Re: Florida Power & Light Company
Proposed Turkey Point Units 6 and 7
Docket Nos. 52-040 and 52-041
Response to NRC Request for Additional Information Letter No. 036 (eRAI 5860)
SRP Section: 02.04.05 Probable Maximum Surge and Seiche Flooding

Attachment: FPL Response to NRC RAI No. 02.04.05-4 (eRAI 5860)

NRC RAI Number: 02.04.05-4 (eRAI 5860)

Figure 1: Effects of PMH Forward Speed on Surge Elevation at the Turkey Point Units 6 & 7 Site

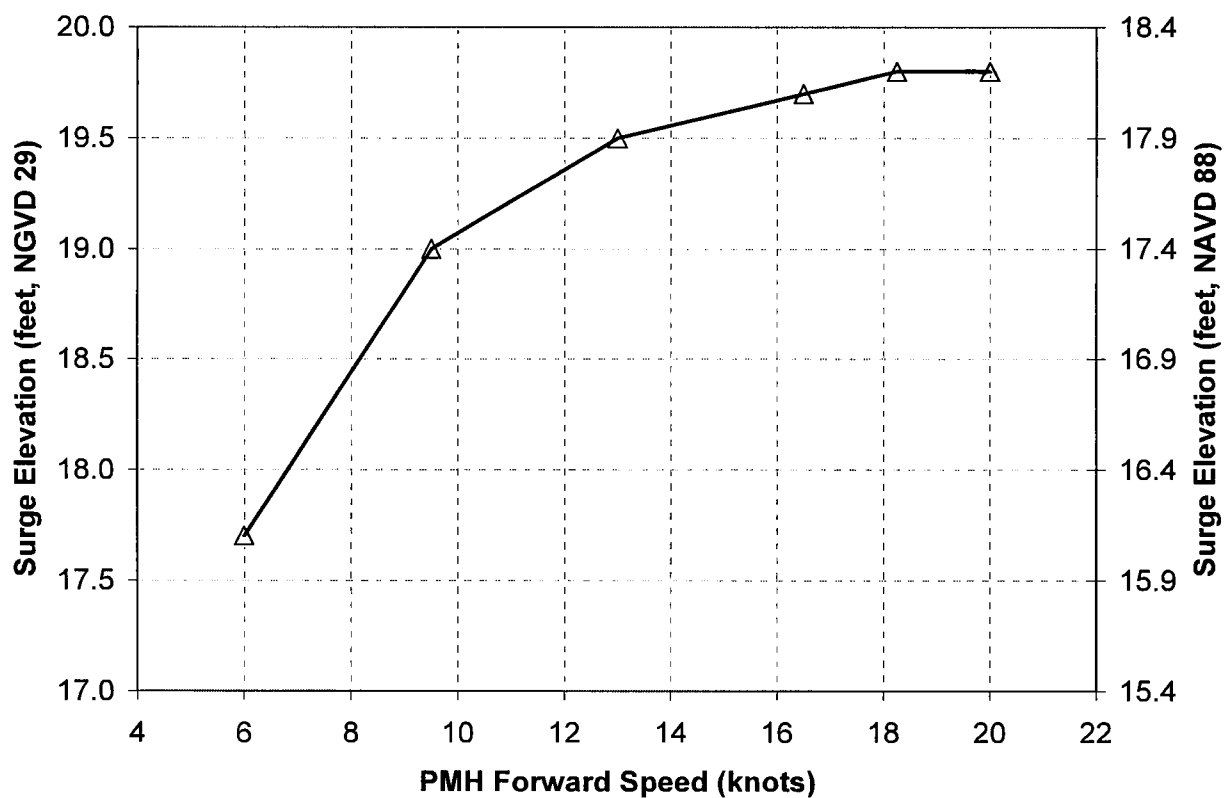
The applicant's analysis of PMH-related storm surge includes apparently limited analysis of the sensitivity of storm surge predictions to variations in input parameters, including PMH forward speed.

Analysis of the effect of PMH forward speed on storm surge considered only two values for PMH forward speed, 6 knots and 20 knots, the upper and lower end of the range specified in NWS 23. The analysis found that the higher value resulted in higher storm surge elevations. Research has shown, however, that storm surge height is not always correlated with storm forward speed; somewhat slower storms sometimes can result in higher surge elevations. Therefore, the analysis may not demonstrate that a 20-knot forward speed is bounding, that is, that values of forward speed between 6 knots and 20 knots would not result in higher storm surge at the site of Turkey Point Units 6 and 7.

Provide reasoning and analysis sufficient to demonstrate that the effect of forward speed on storm surge elevation at the site of Turkey Point Units 6 and 7 has been bounded.

In response to this RAI, additional storm surge simulations for the above bounding PMH condition were performed with different forward speeds: 6 knots, 9.5 knots, 13 knots, 16.5 knots and 18.25 knots. The results of the analyses are shown in Table 1 and Figure 1, which demonstrate that the surge elevation at the site increases with increasing forward speed within the range specified in NWS 23. Therefore, it is concluded that the PMH condition, which uses the NWS 23 upper bound forward speed of 20 knots to establish the PMSS as described in FSAR Subsection 2.4.5.2.2, remains bounding.
